Westinghouse Electric Company LLC
Hematite Decommissioning Project
3300 State Road P
Festus, MO 63028
USA

Subject: Revised Technical Basis for Characterization of Decommissioning Soils Waste That is Subject to the Alternate Disposal Request for U.S. Ecology Idaho, Inc. (License No. SNM-00033, Docket No. 070-00036)

Technical Basis for Characterization of Decommissioning Soils Waste to be Sent to U. S. Ecology Idaho, Inc.

Revision 1

**Figure 1
 Waste Handling Flowchart**

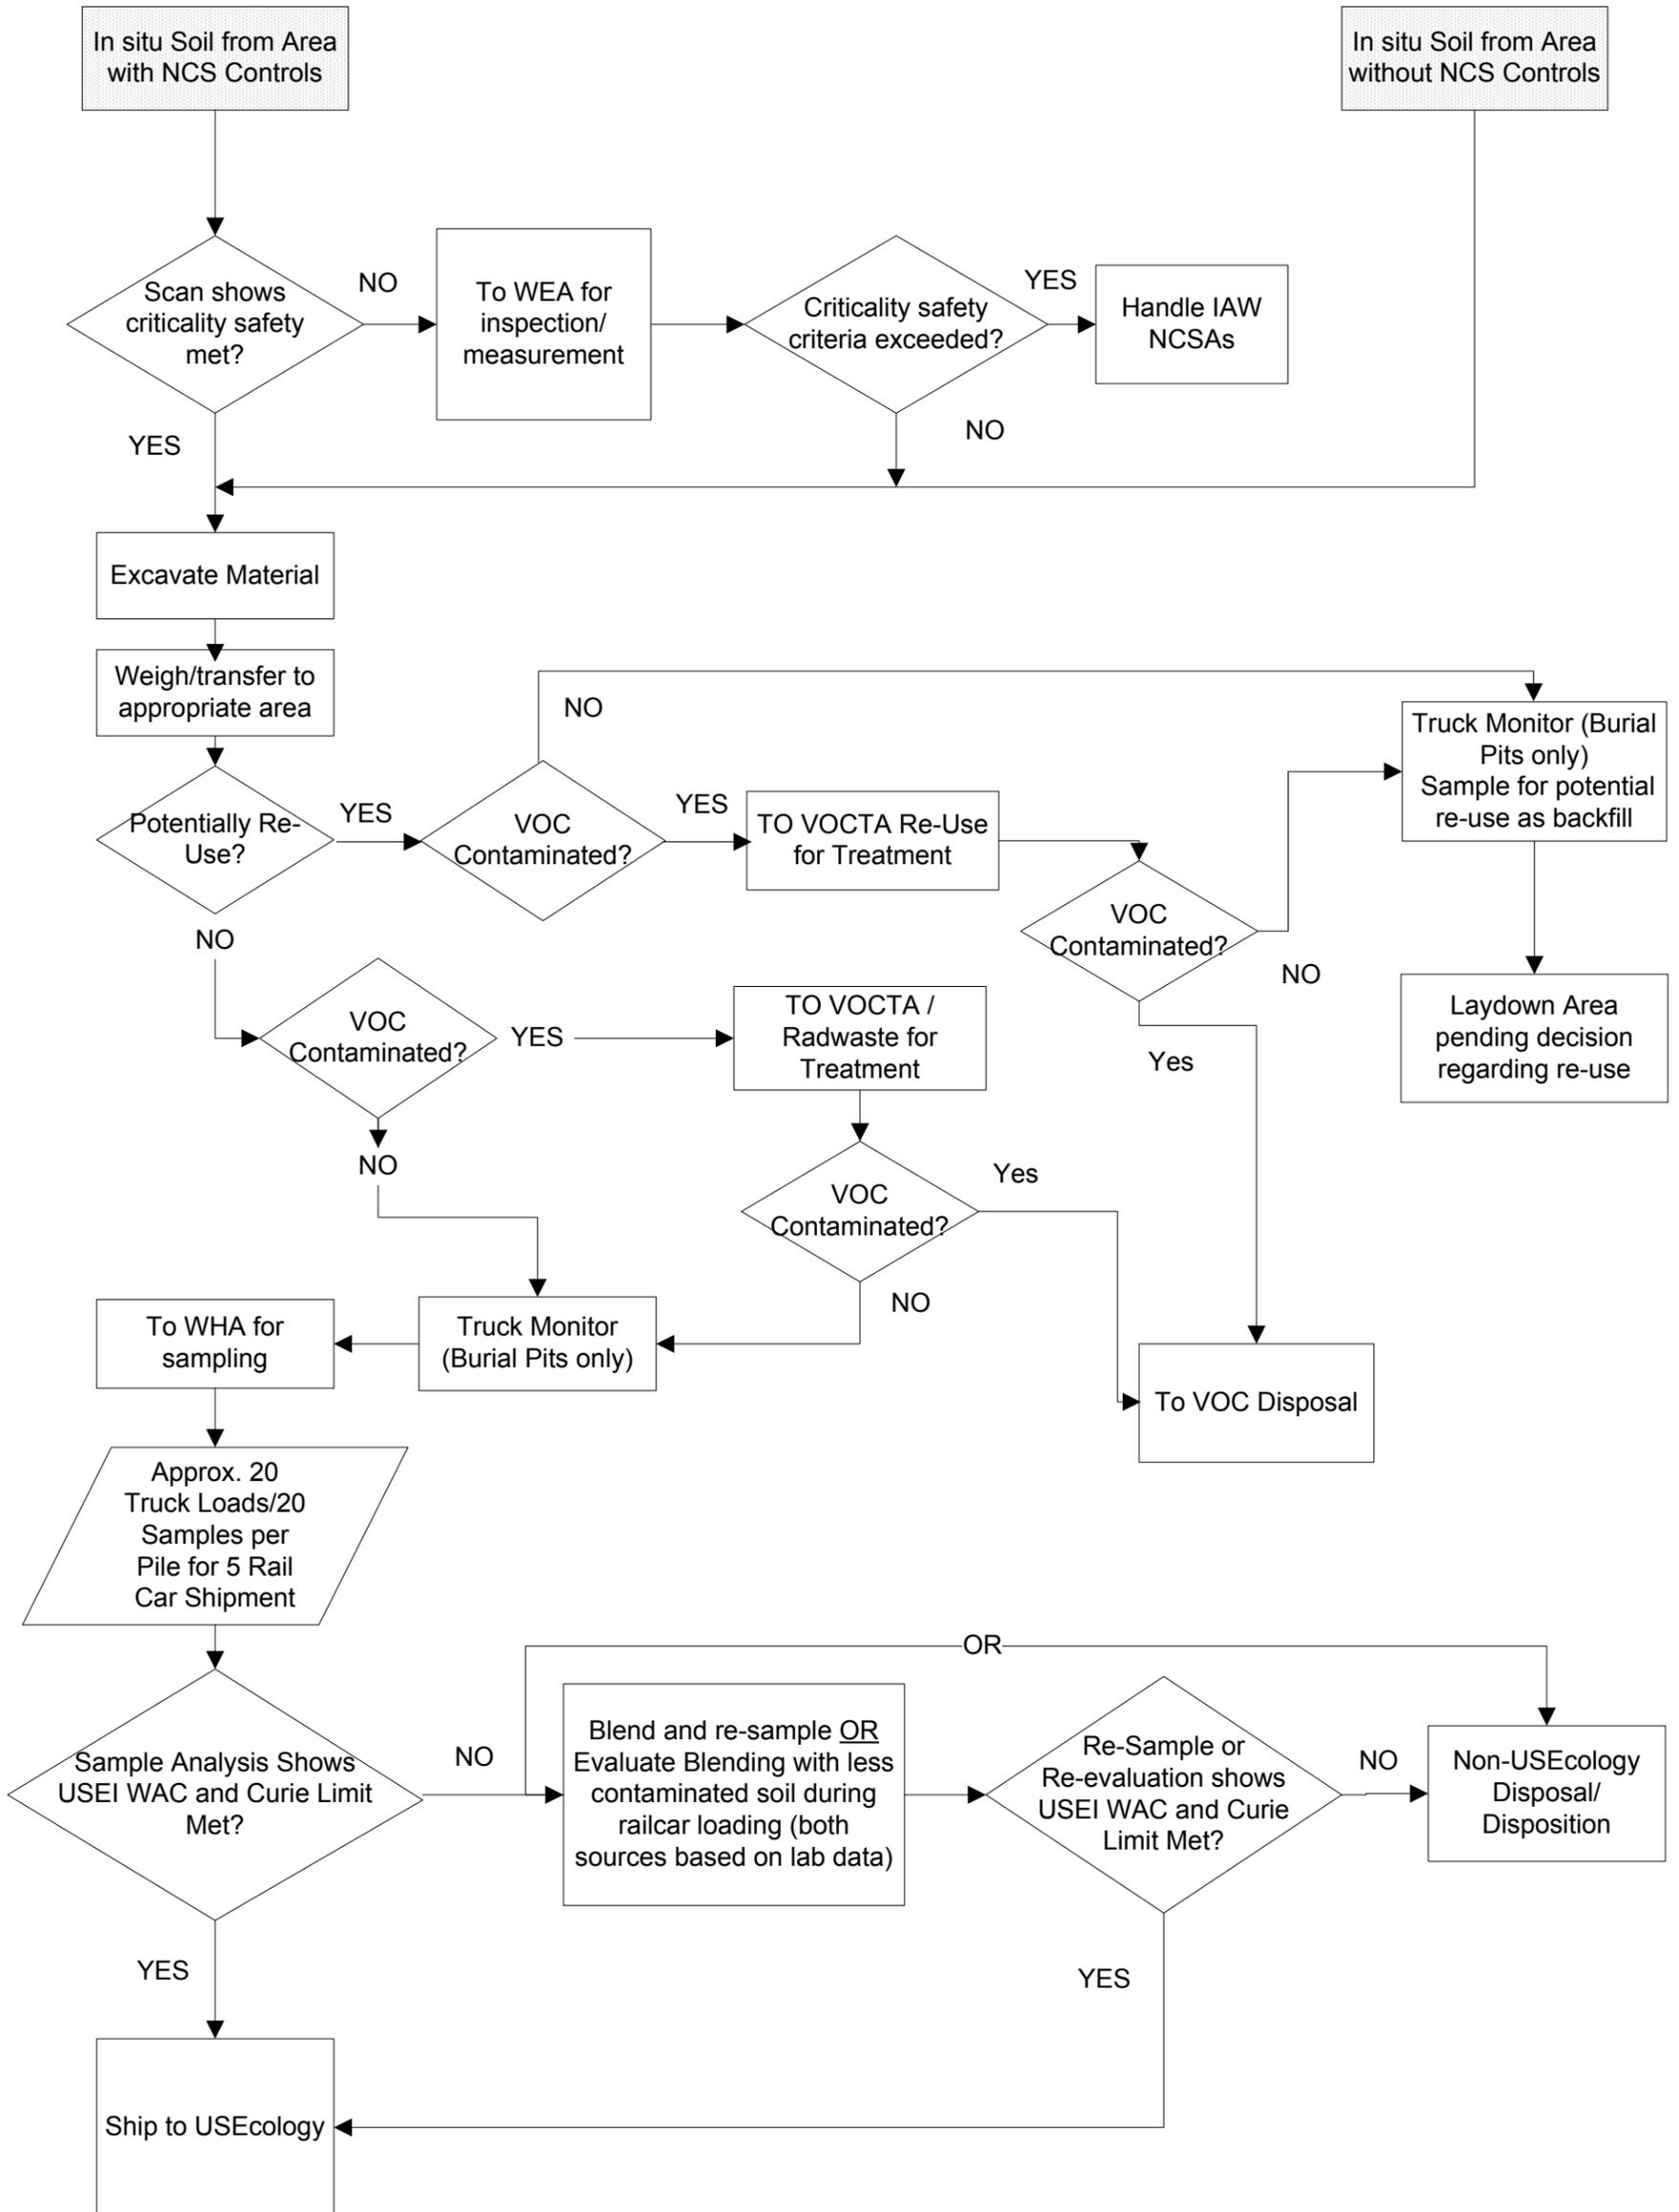
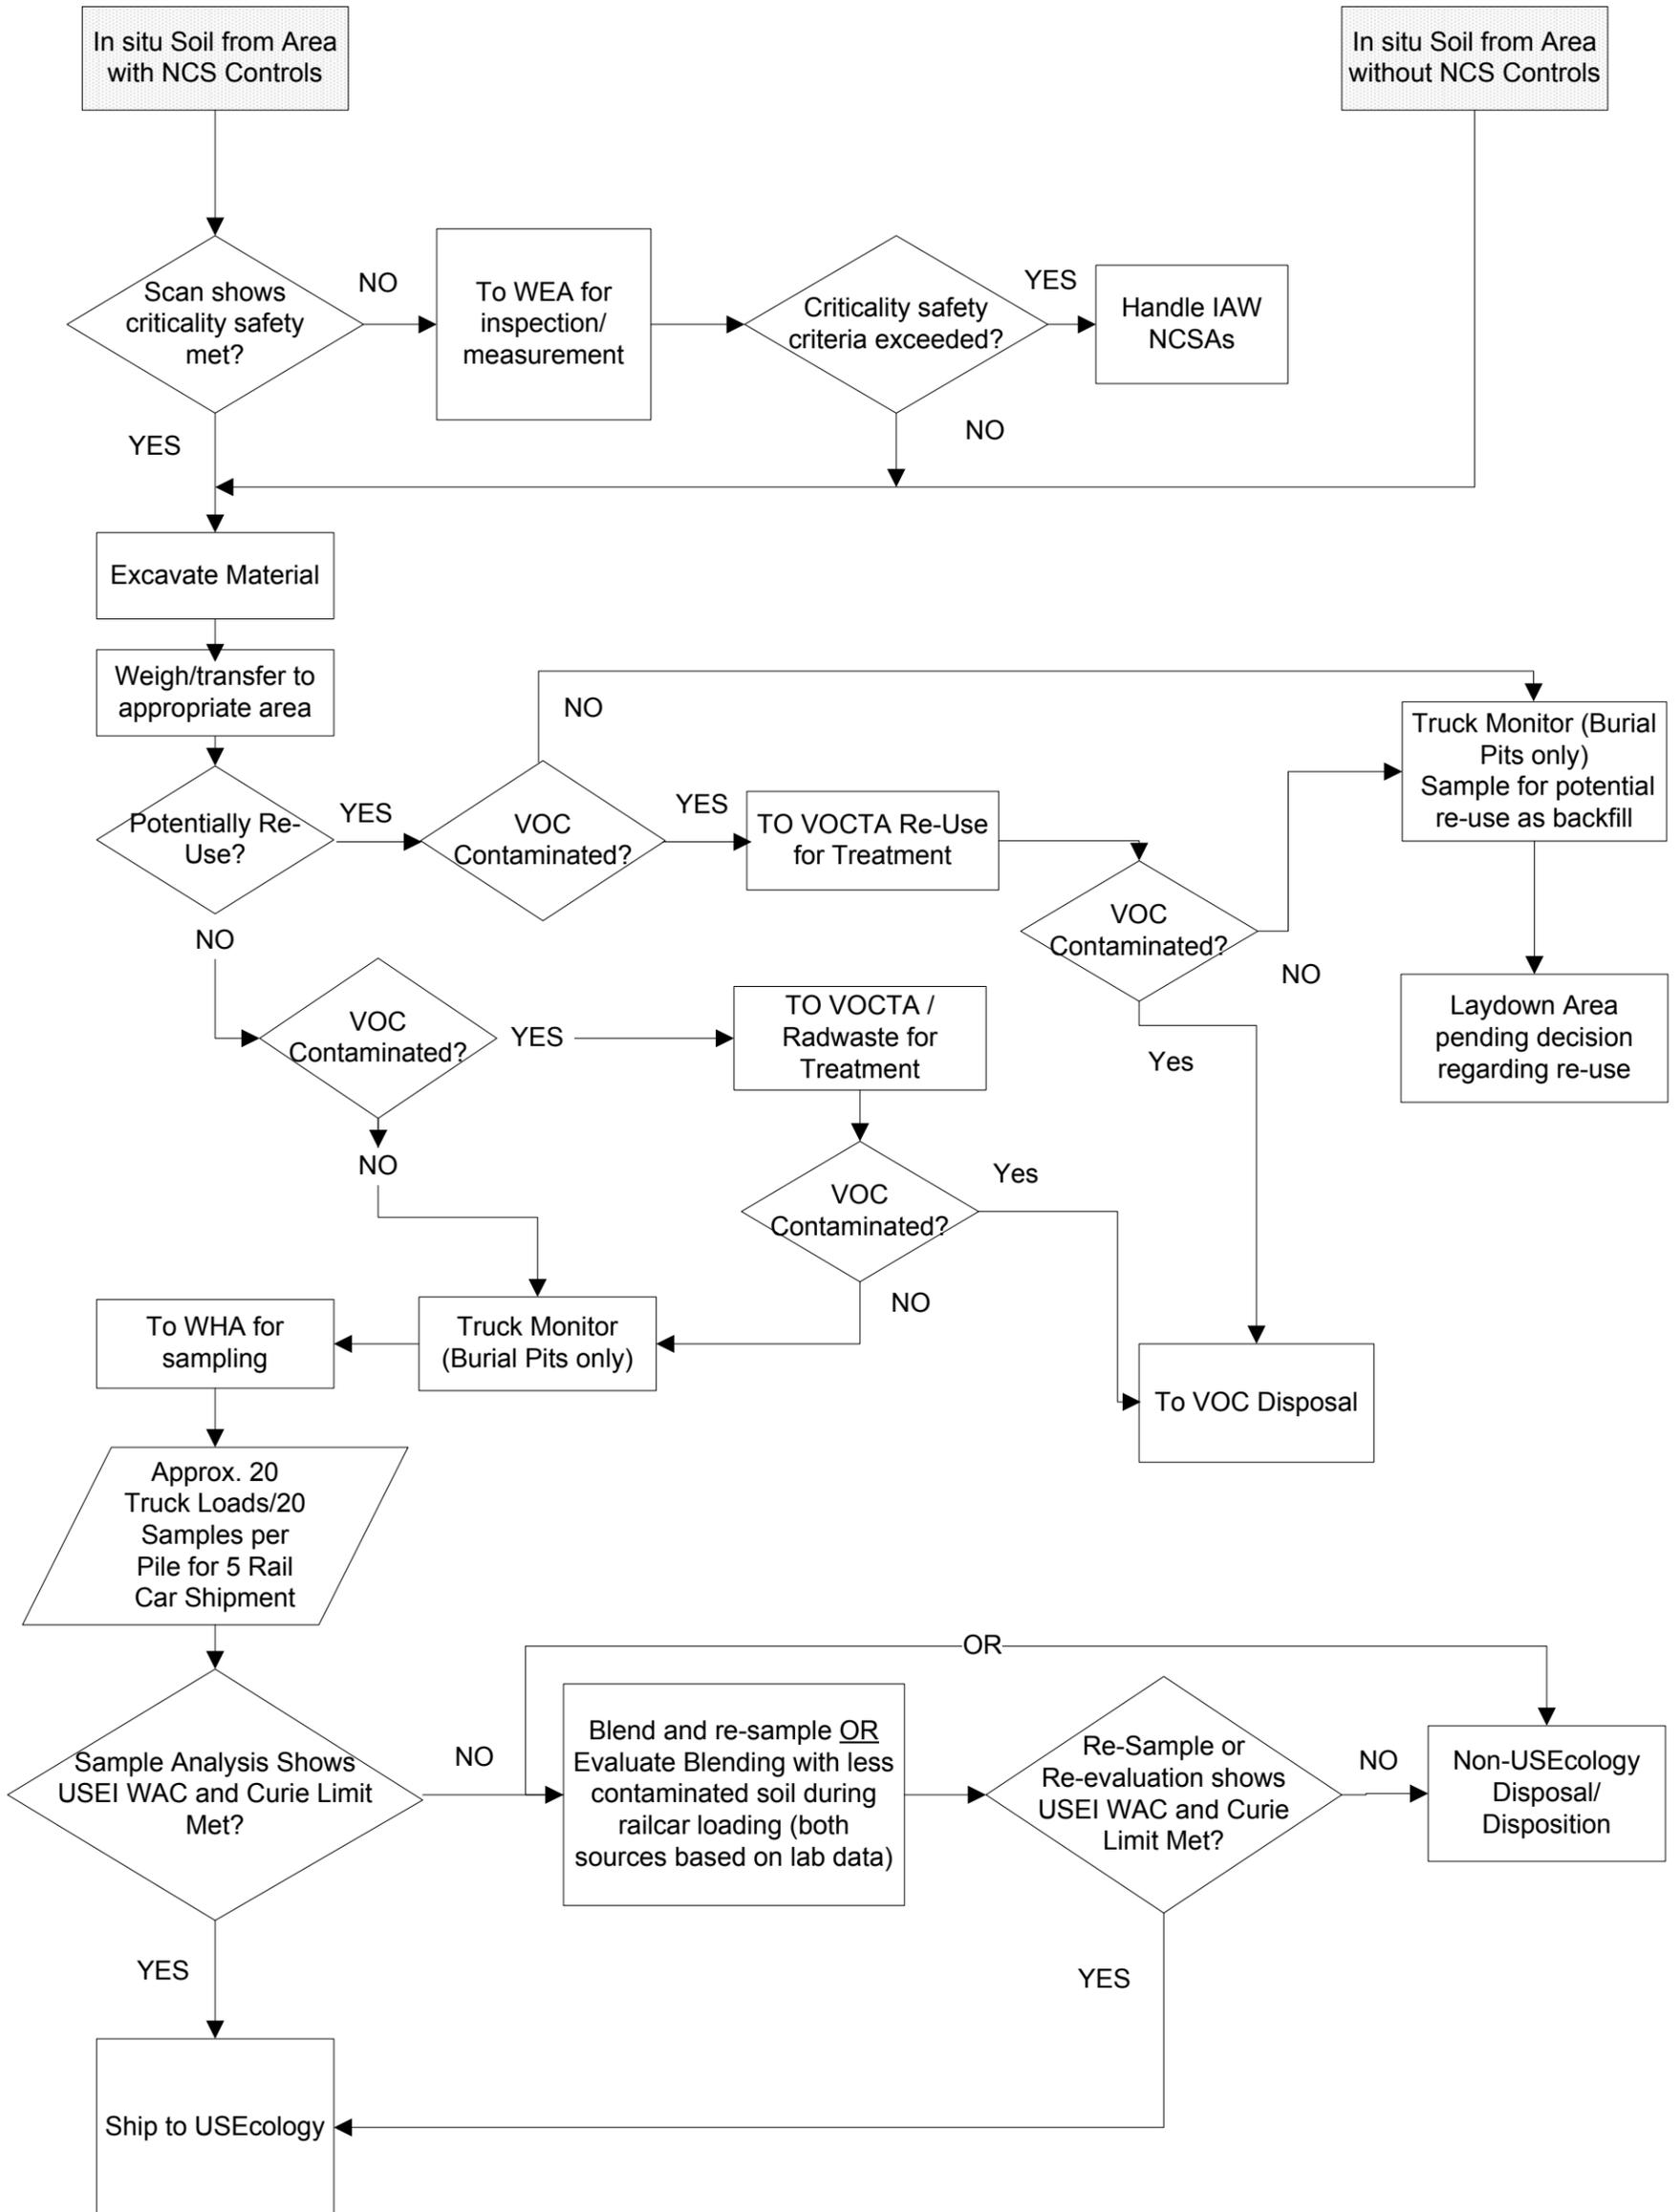
The HDP material handling process, including the multiple material handling decision points and shipping limit-based decision points, is shown in the Figure 1 Waste Handling Flowchart.

The HDP material handling process, including the multiple material handling decision points and shipping limit-based decision points, is shown in the Figure 1 Waste Handling Flowchart.
